Office Action Summary

10/501,748

DETAILED ACTION

FIG. 1

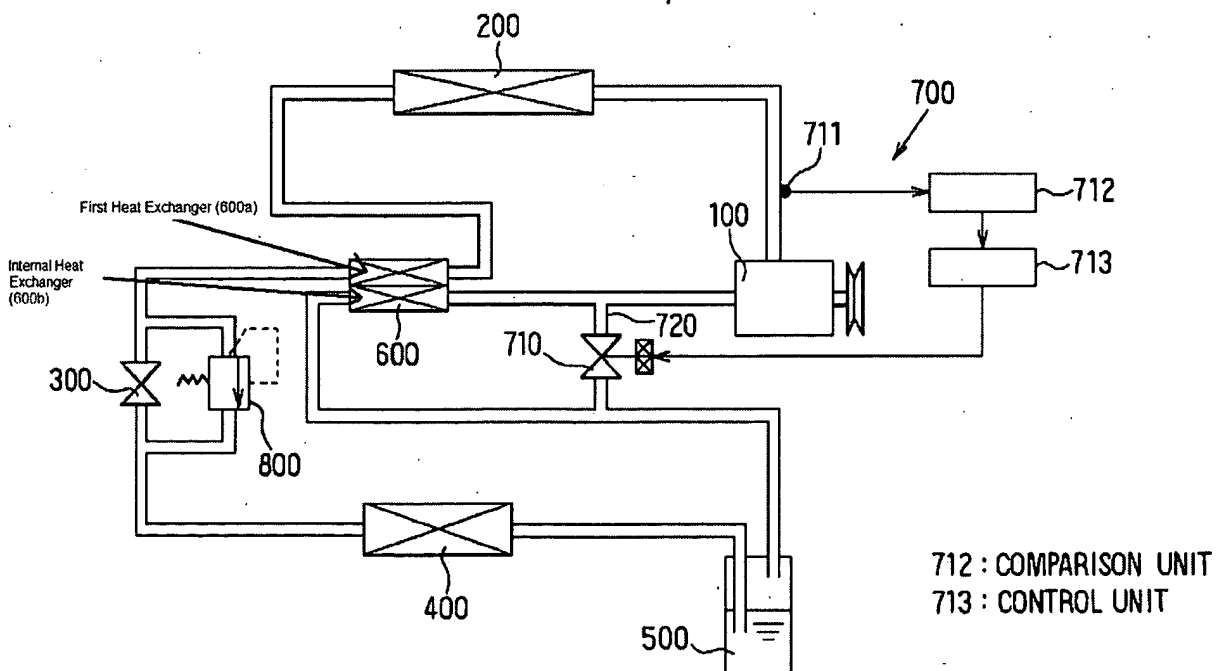
In regard to claim 1, Kuroda et. al. teach a refrigeration cycle device comprising a refrigeration cycle which is formed by sequentially connecting a compressor (100) which compresses a refrigerant that contains carbon dioxide (col 5 lines 13-14), a first decompressor (800) that is capable of decompressing the compressed refrigerant (col 5 lines 19-22), a first heat exchanger (600a) which performs heat exchange between the refrigerant which goes through said first decompressor (800) and ambient air (see annotated Fig. 1 above) and an internal heat exchanger (600b) which performs heat exchange between the refrigerant having passed through said first heat exchanger and the refrigerant before being sucked by said compressor (see annotated Fig. 1 above). The term "sequentially" is presumed to mean that the compressor (100), first heat exchanger (600a) and first decompressor (800) are all connected in a regular order and that the refrigerant flows through all of the above elements, thus connecting them.

Kuroda et. al. also teach a second decompressor (300) which decompresses the refrigerant having passed through the internal heat exchanger (600b) (see annotated Fig. 1 above), a second heat exchanger (400) which performs heat exchange between the refrigerant which is decompressed by the second decompressor (300), ambient air and internal heat exchanger (600b) (see annotated Fig. 1 above and col 8 lines 24-27). Since the refrigerant cycles

Kuroda et. al. also teach a heater core (200) (col 5 lines 14-16) which is arranged downstream of the second heat exchanger with respect to flow of ambient air and a radiator (200) (see annotated Fig. 1 above) wherein air conditioning capacity is adjusted by a degree of opening the second decompressor (300) at the time of heating and dehumidifying (col 8 lines 1-13).

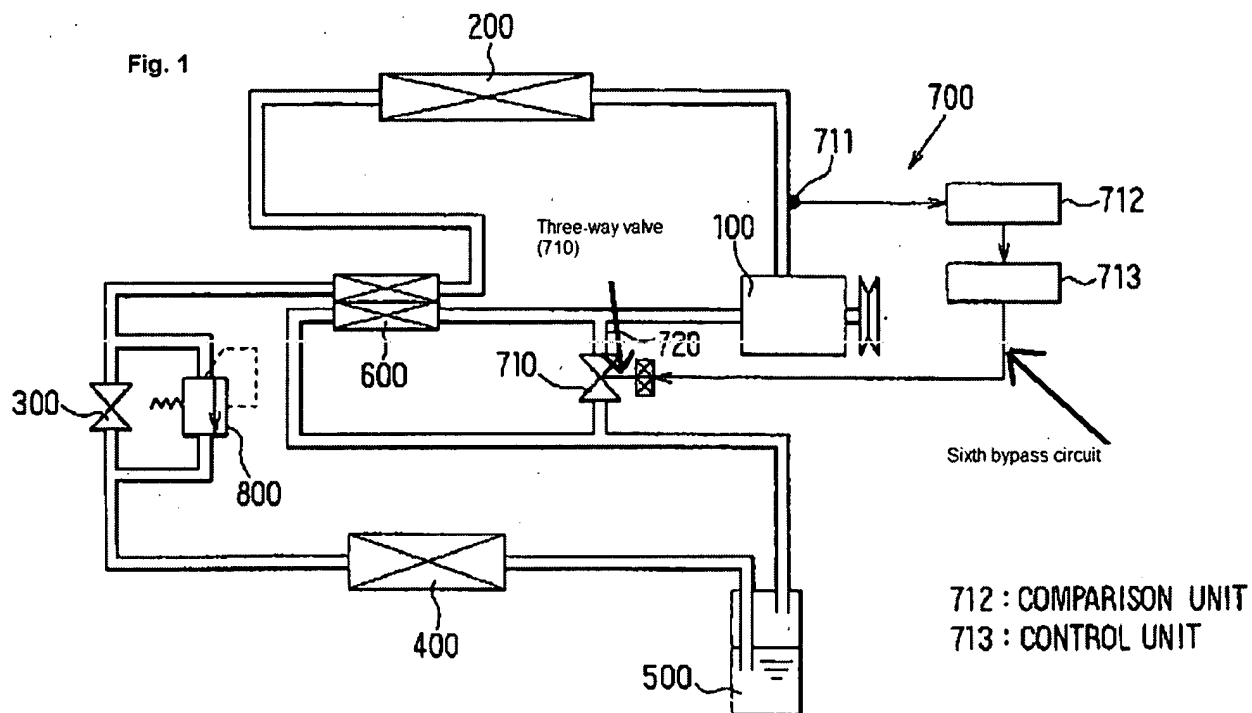
Kuroda et. al. also teach a first three-way valve (710) which is disposed between an outlet of said first heat exchanger (200) and an inlet of said internal heat exchanger (600a) (see Fig. 14).

Kuroda et. al. also teach a fourth bypass circuit which is connected by having one end thereof disposed between an outlet of said heat exchanger (600a) and an inlet of said fifth open/close valve (751) and the other end formed of said first three-way valve (710 and 720) (col 8 lines 36-43 and col 9 lines 50-52). Masahiro et. al. teach a that the heat exchanger is a refrigerant-water heat exchanger (2). It would have been obvious to one of ordinary skill in the art at the time of the invention to place the refrigeration-water heat exchanger (2) as taught by Masahiro et. al. in the refrigeration cycle as taught by Kuroda et. al. because using a heat exchanger that uses both CO₂ and water is less expensive and easier to maintain than a system that uses solely CO₂ as a refrigerant.
